Docket No. 52-002

Subject: Response to NRC Requests for Additional Information

Reference: Letter, Structural and Geosciences Branch RAIs, T. V. Wambach (NRC)
to E. H. Kennedy (C-E), dated September 26, 1991

RESPONSE TO NRC REQUESTS FOR ADDITIONAL INFORMATION
STRUCTURAL AND GEOSCIENCES BRANCH

Fig. 3d Spectral Acceleration for Target Spectrum and for the Vertical Synthetic Time History -- Spectral Damping = 0.07

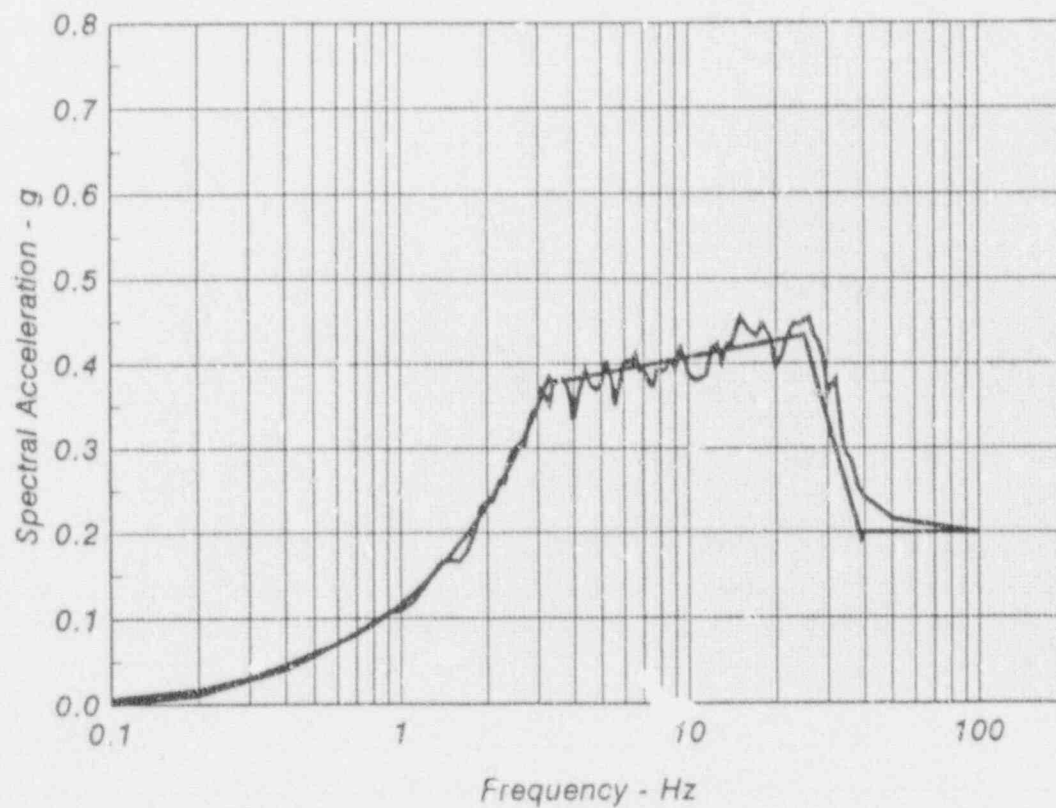
Section 3.7.1.2 - Figures 3.7-25 through 3.7-27 are for damping values of 5 percent. To show the appropriateness of these time histories, provide and discuss similar figures for other damping values that will be used in the design of all Category I structures, systems, and components.

The synthetic time histories H1, H2 and V were generated by obtaining a reasonably conservative envelope to the target smooth spectrum at a spectral damping ratio of 5 percent. The response spectra calculated for these synthetic time histories are presented in CESSAR-DC Figs. 3.7-25 through 3.7-27. The procedure used to obtain the synthetic time histories and the frequencies at which spectral ordinates were calculated are summarized in the response to RAI 220.8.

The spectral ordinates of the target smooth spectrum were estimated for spectral damping ratios other than 5 percent using, as a basis, the spectral amplification factors recommended by Newmark and Hall (1982). The following median and 84th percentile factors were proposed by Newmark and Hall:

The above equations were used as follows: (i) the spectral amplification factor for a given spectral damping ratio was divided by that for $\beta = 5$ percent to obtain an "adjustment factor" for the given spectral damping ratio; and (ii) the adjustment factor was then multiplied by the spectral ordinates of the target smooth spectrum (for $\beta = 5$ percent) to obtain the spectral ordinates of the target smooth spectrum at the desired spectral damping ratio. The adjustment factors were calculated for both the median and the 84th percentile amplification factors; as expected the two sets of adjustment factors were very close (differences were no more than about 6%). For the reasons outlined in response to RAI 230.4, the adjustment factors based on the median amplification factors were used herein to obtain spectral ordinates for the target smooth spectrum at spectral damping ratios of 1, 2 and 7 percent in addition to those that had been developed for 5 percent damping.

Finally, the spectral ordinates for damping ratios of 1, 2, 5 and 7 percent were calculated for the synthetic time histories, H1, H2 and V and these were compared with the target smooth spectrum for the appropriate damping ratio. These comparisons are provided herein in Figs. 1a through 3d.

Figure 1a shows the comparison for H1 at a damping ratio of 1 percent, Fig. 1b is a similar comparison at a damping ratio of 2 percent, Fig. 1c is for a damping ratio of 5 percent and Fig. 1d is for a damping ratio of 7 percent. Corresponding comparisons are presented in Figs. 2a, 2b, 2c and 2d for H2 and in Figs. 3a, 3b, 3c and 3d for the vertical synthetic time history, V.

The results shown in Figs. 1a through 3d indicate: (i) the spectral ordinates of the synthetic time histories provide a reasonably conservative envelope to the target smooth spectrum at damping ratios from 1 to 7 percent for the frequencies of interest; and (ii) the amount of conservatism increases with decreasing damping.

CONTAINMENT PRESSURE VS. TIME

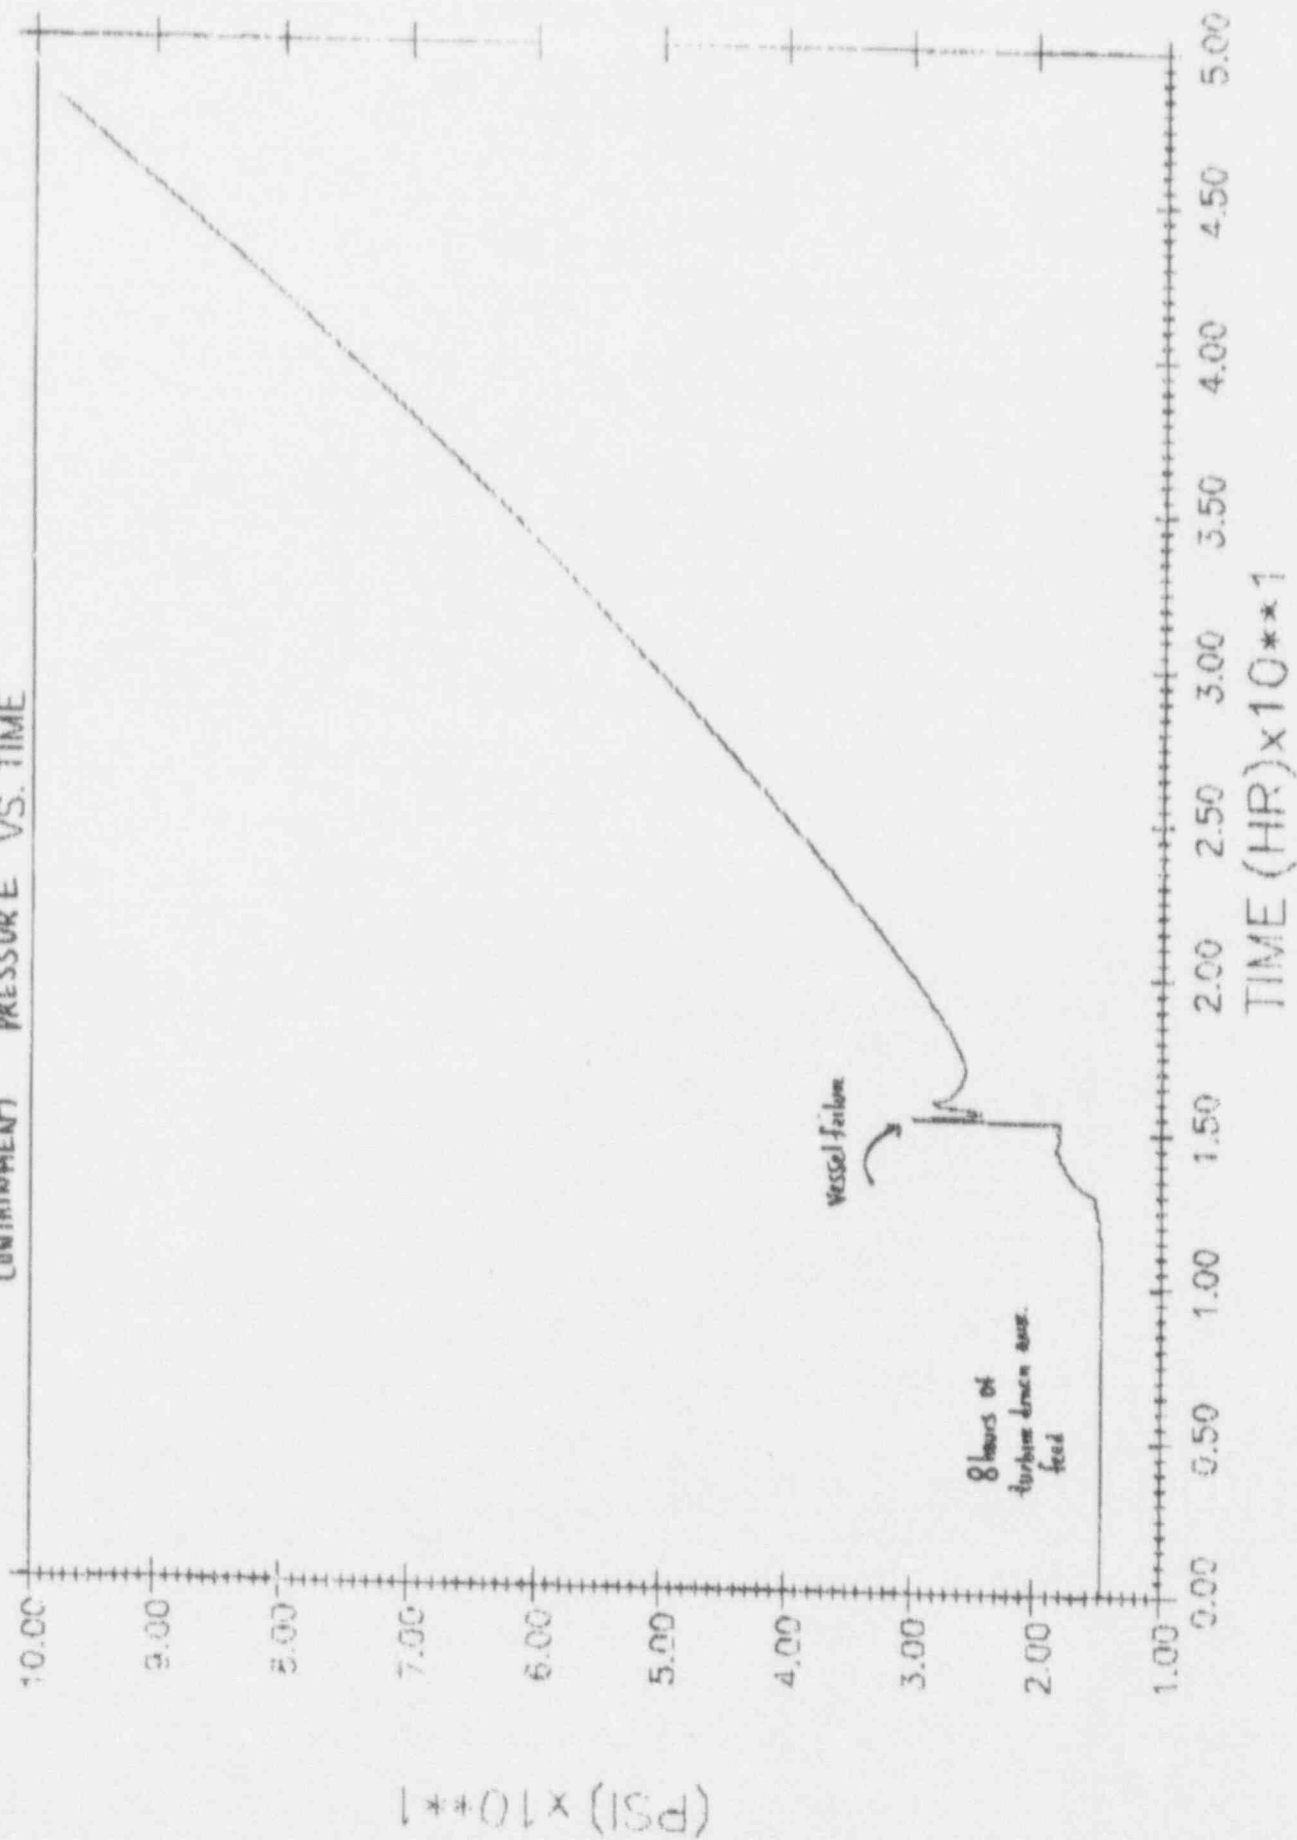
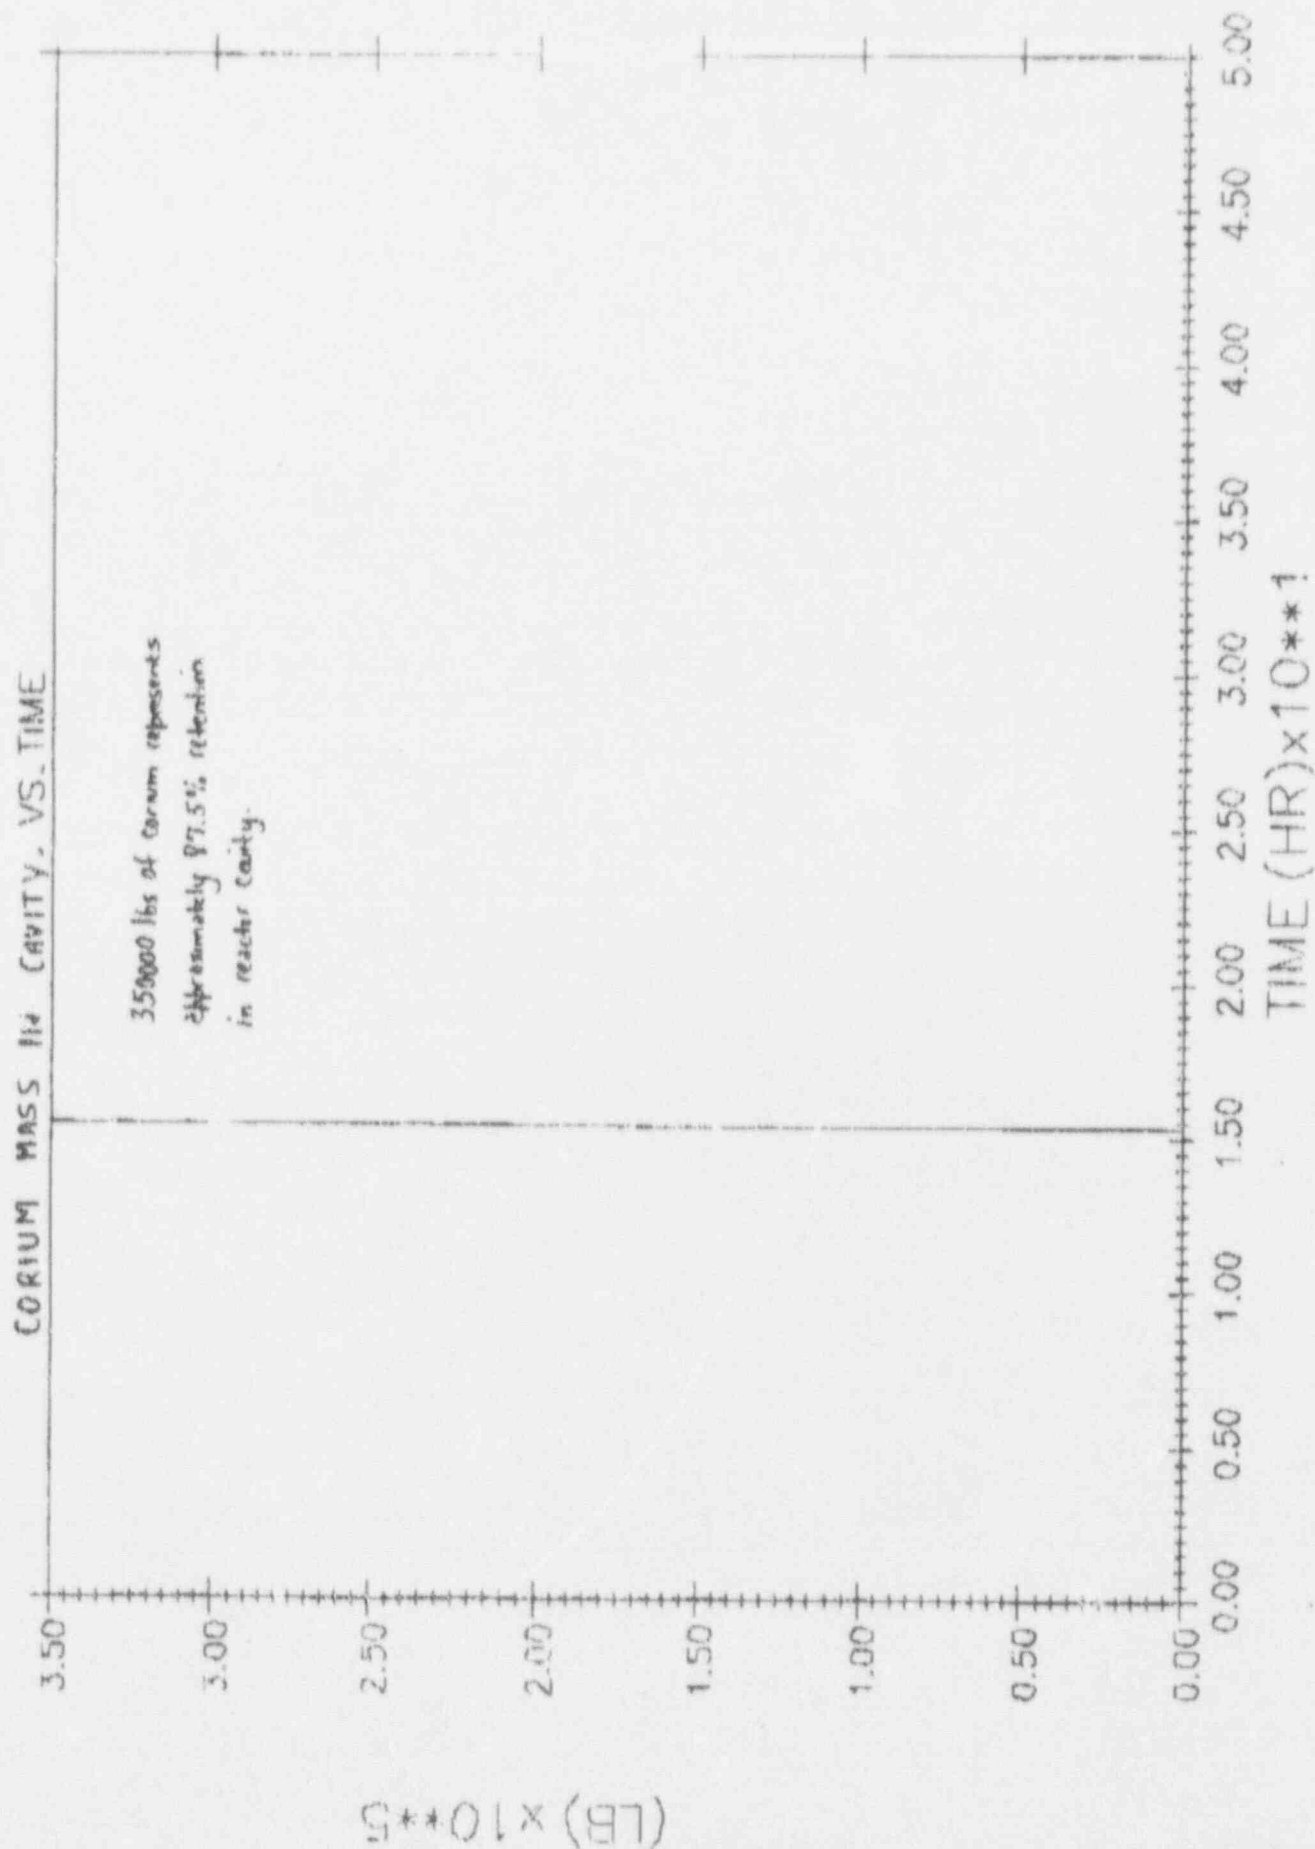
Section 5.4 Appendix B addresses the staff guidance of Containment Conditional Failure Probability (CCFP) of 0.1. The SRM related to SECY-90-016 also recommends the use of deterministic objectives. As such, the staff (ESGB) would prefer a deterministically established containment performance objective, such as establishing containment structural failure criteria based on the maximum strains (in general shell and in localized areas) as limited by global restraints and functionality of various features related to the mitigation of the consequences of accidents. Provide information regarding the ultimate capacity of the containment considering the above attributes. (see also RAI 720.24 in Section 7 of Appendix B).

Combustion Engineering agrees that the staff position on Issue 11 of SECY-90-016 permits a demonstration of adequate containment performance by either a 0.1 Containment Conditional Failure Probability (CCFP) criterion or by a deterministic goal that offers equivalent protection. It is our understanding that the staff is concerned with the use of the 0.1 CCFP criterion because of the uncertainties inherent in the PRA methods, especially those associated with seismic hazards. Therefore, C-E is investigating the use of an alternate, deterministic criterion to gain additional insight into System 80+ containment performance for severe accident conditions.

For this investigation, the choice of the severe accident sequences and the assumptions on degraded core behavior will be based on best-estimate judgments which will be consistent with the MAAP analysis reported in the PRA documented in Appendix B of CESSAR-DC. The purpose of this analysis is to determine the time response of the containment pressure and temperature for a representative severe accident scenario. Using this information, the length of time the containment pressure remains below the ASME Service Level C criterion is determined. For the System 80+ containment, the ASME service Level C criterion is about 156 psia at a containment temperature of 350 degrees F.

Using the above guidelines, a station blackout scenario was simulated using the MAAP computer code. With battery power available, auxiliary feedwater flow is assumed to be provided by the turbine driven auxiliary feedwater pump for a period of eight hours. Following the unavailability of auxiliary feedwater at eight hours, the vessel fails at 15.5 hours due to the loss of core cooling. Cavity flooding is assumed to occur prior to vessel failure. Combined with the deentraining characteristic of the System 80+ cavity, this will result in the retention of approximately 87.5% of the corium within the cavity. For this scenario, the containment pressure remains below 100 psia for up to 50 hours after the initiation of the station blackout (Please see attached Figure 1). The containment temperature does not exceed 350 degrees F during this time frame (Please see Figure 2). These results demonstrate that, for this best estimate severe accident scenario, the containment pressure remains well below ASME Service Level C criterion of 156 psia for more than 50 hours.

The ultimate pressure capacity for the System 80+ containment is approximately 185 psia at a temperature of 290 degrees F. This value is not considered specifically in the above evaluation, but is included here to demonstrate the additional margin to System 80+ containment integrity during a severe accident.
